RECEIPT DATE: 6/26/18 **ONSITE SEWAGE DISPOSAL SYSTEM**

PROPERTY ADDRESS: 8522 BLOUNTS LANE, FULTON, MD 20759

I am reviewing the proposal for construction of a residence for William and Dana Walker at 8522 Blounts Lane in Howard County, MD. During review, it has become apparent that I need to communicate several issues of immediate concern for the Howard County Health Department, Bureau of Environmental Health.

ON-SITE SEWAGE DISPOSAL SYSTEM PLAN
 Parcel 53 (1.350 Acres)
 8522 Blounts Lane - Fulton, MD
 Tax ID - 05-372712
 L.11358 F.593
 Tax Map No. 45 Fifth Election District
 Grid 12, Parcel 53
 Howard County, Maryland

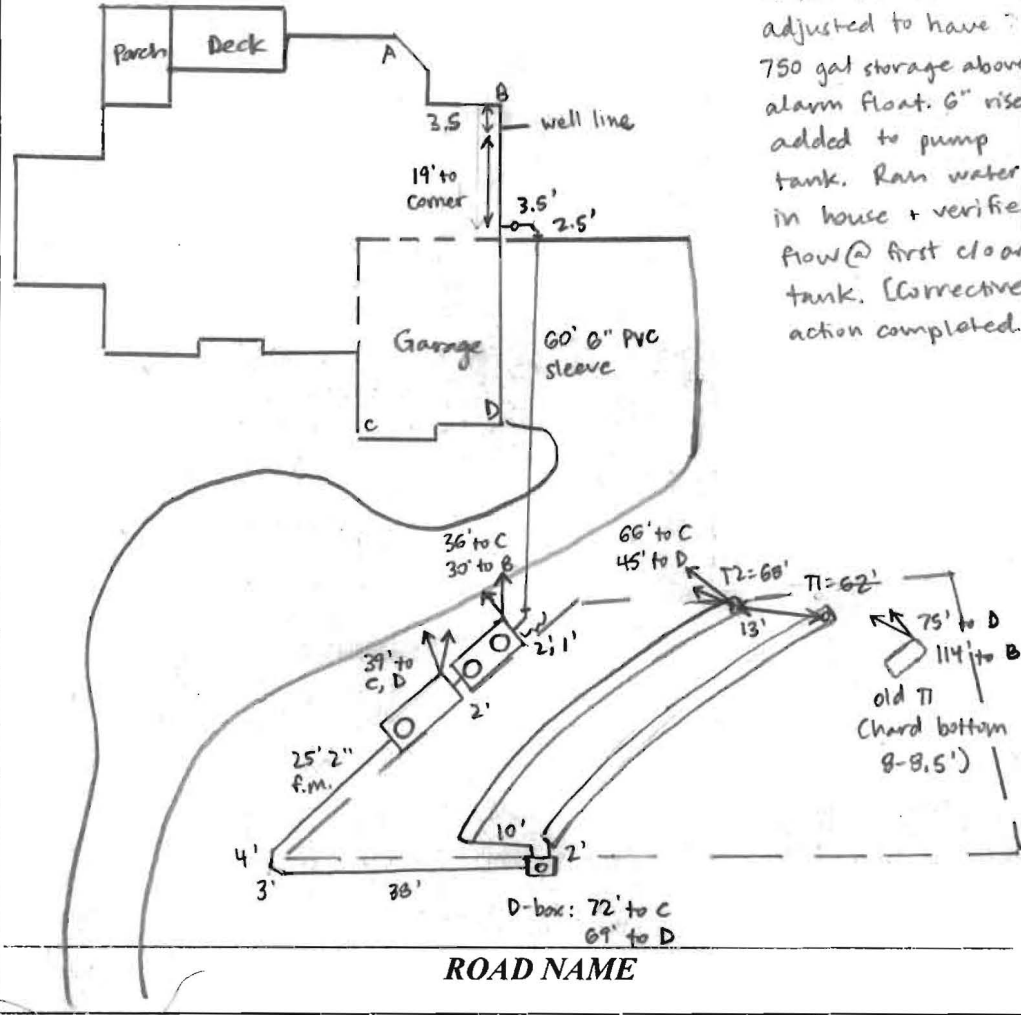
8/2/18 Floats adjusted to have 750 gal storage above alarm float. 6" riser added to pump tank. Rain water in house + verified flow @ first cloard tank. [Corrective action completed.]

6/27/18 Met Rick from Double K on site for layout. Two SDA stakes on N edge present, others not. Rick scaled off LOD + flagged rest of area. Shot contour + laid out a 57' + 58' trench. Tanks not staked, found area for them 7' off future driveway against SDA line. Sewer line not coming out where shown on plan. Shot elevations + septic tank will have 1.5' cover, a bit more over pump tank. Fin. to run along driveway out of septic hole. Rick will dig end of T1 to 11.5' to check for 4' buffer + fill back in

to 7.5' bottom if 4' buffer is met. 6/29/18 Rick dug @ T1 end - hard bottom @ 8-8.5'. Found space for 1x57' trench below original T2. Dug @ end of new T2 - hard bottom @ 11'. Change specs to 7' bottom, inlet 3.5', 2x66' trenches. Pipe laid from house to tank location, 60' 6" PVC sleeve installed under driveway. Need house connection. 7/2/18 Tanks set, 2" force main installed around SDA up to D-box and T1 dug, 3' wide 7' bottom. 7/2/18 T2 dug + stone added. 3' wide, 3.5' inlet. Need pump + alarm test and house connection. 8/1/18 On site for pump + alarm test. Pump pumps effluent to D-box, alarm sounds. Need 6" riser extension on pump tank. Need 31" storage (= 750 gal) above high alarm float. Must confirm house connection

by running water in house + looking into 15' clo outside house. [Corrective action.]

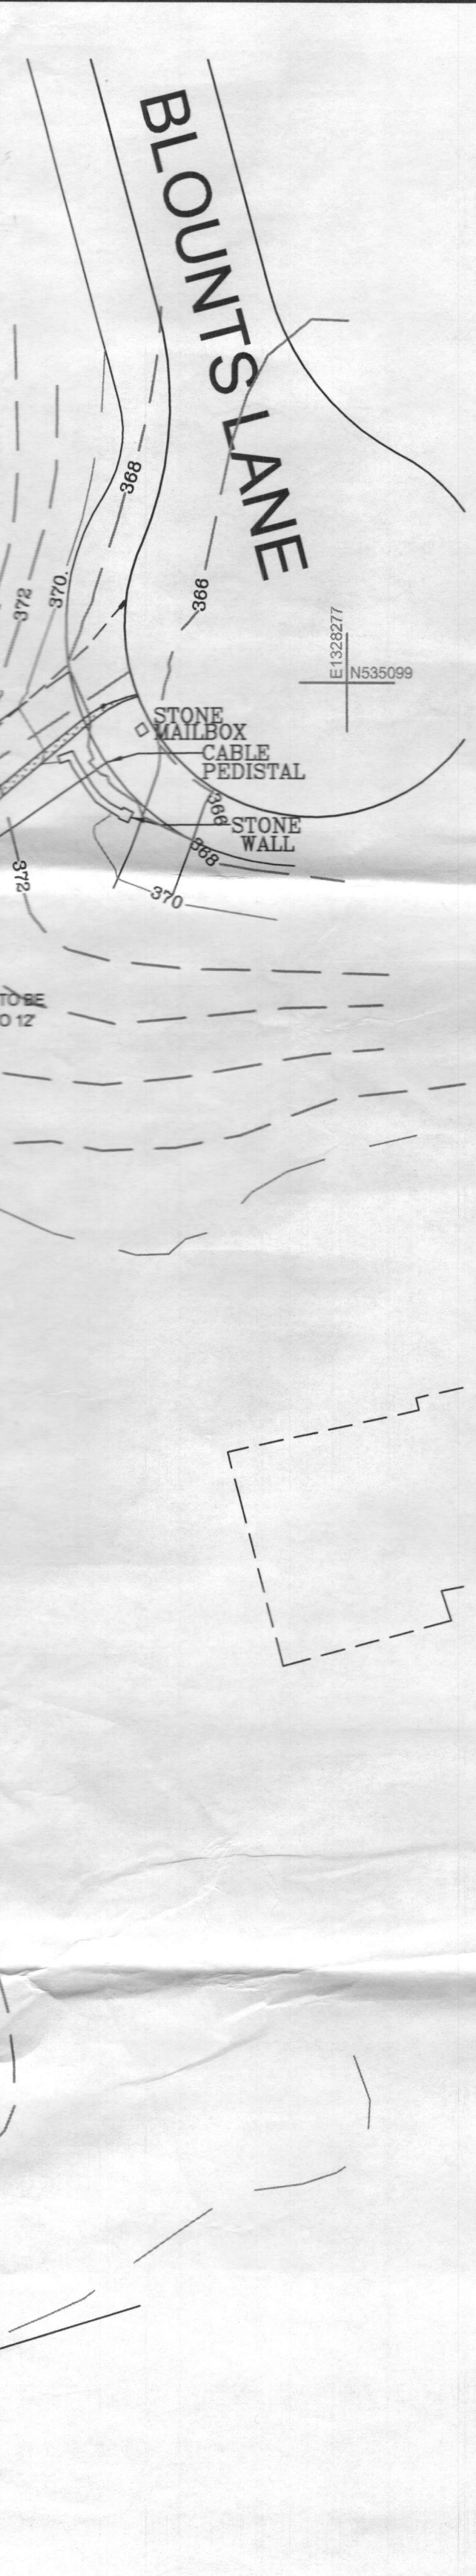
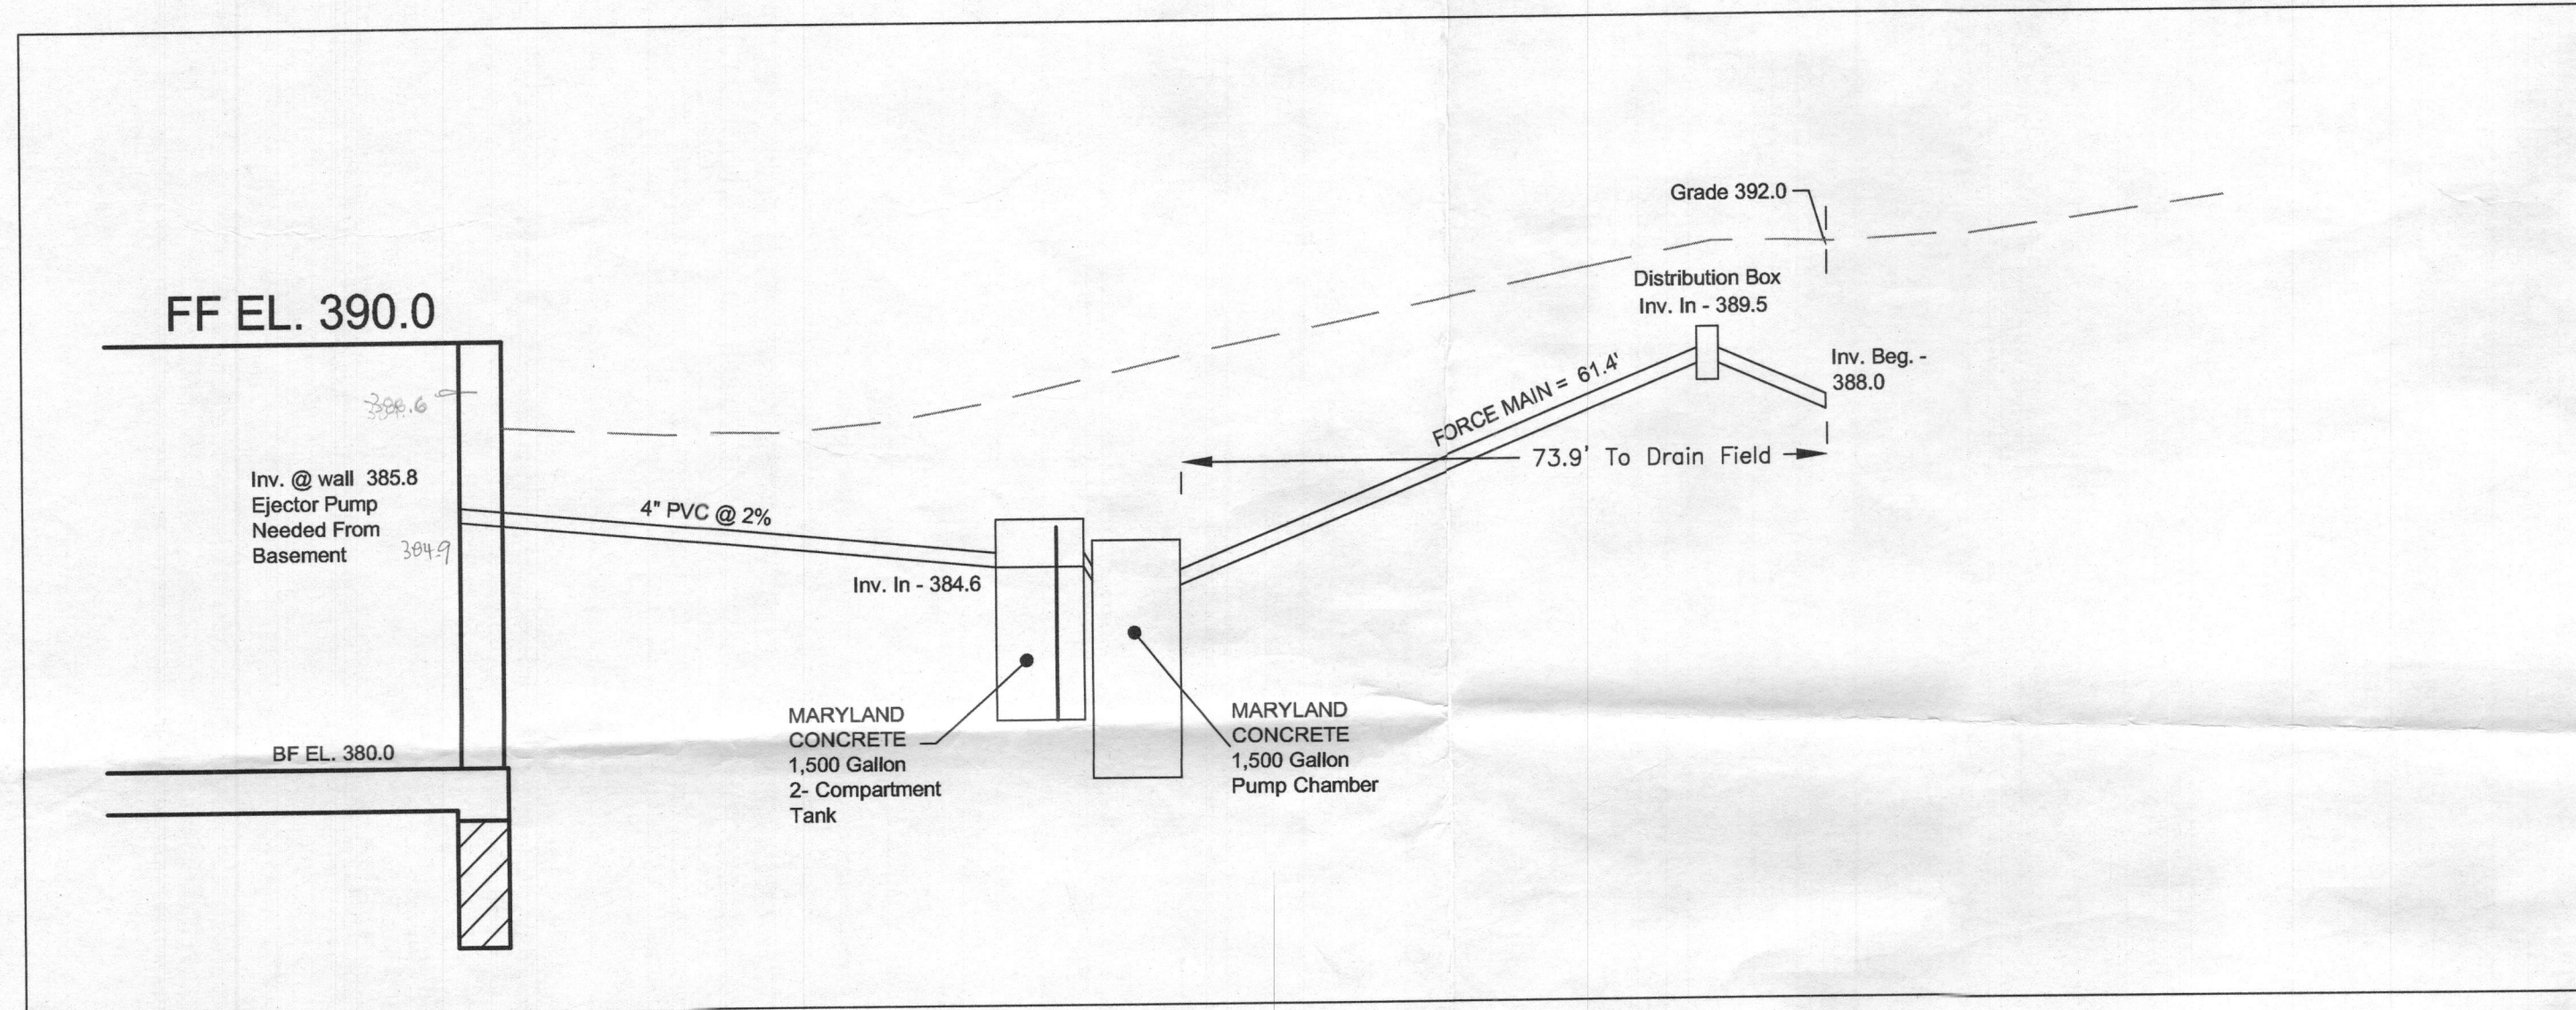
1. The illustration on the plan implies grading over much of the parcel area, including the Sewage Disposal Areas (SDA). Be advised that grading is prohibited in SDA. The Plot Plan will have to be edited, primarily due to re-delineating the Limit-of-Disturbance.

2. To prevent damage during grading operations/site preparation, both sections of SDA are to be enclosed by a temporary fence. Material such as blaze orange netted plastic is appropriate as it is highly visible and easily installed.

3. The water line to serve the Walker residence must be installed in a relatively narrow strip between the property line and a Forest Conservation Easement. The property line must be marked by a surveyor, at least from the property corner near the well to a point past where the water line will turn toward the house. Similarly the boundary of the Forest Conservation Area must be marked by a surveyor as it approaches the area of the well easement.

4. The person who digs the trench for the water line must be informed about the water line that serves Lot 3 (8520 Blounts Lane). If it is possible to locate the water line serving 8520 Blounts Lane, the ground surface should be marked with a highly visible paint before excavation of the trench.

5. The water line serving the Walker residence must pass under the water line serving 8520 Blounts Lane, and it must be sleeved at the crossing of the two pipes. Please inform the person installation the water line about this requirement in a timely manner.

5. The existing wells shown on this plan (well Tag HO-95-1000 and HO-95-0329, respectively) have been field located and are accurately shown.
6. Other than the installation of trenches, disturbance within each SDA is limited to the clearing of trees and evening of surface for the purpose of establishing new lawn area. Cut and Fill and re-shaping of contours is not allowed.

7. Both sections of SDA are to be enclosed by a temporary fence (such as orange blaze) once the initial tree clearing has been completed.
8. New water line serving 8522 Blounts Lane must pass under the existing water line serving 8520 Blounts Lane, and must be sleeved at the crossing of the two pipes.
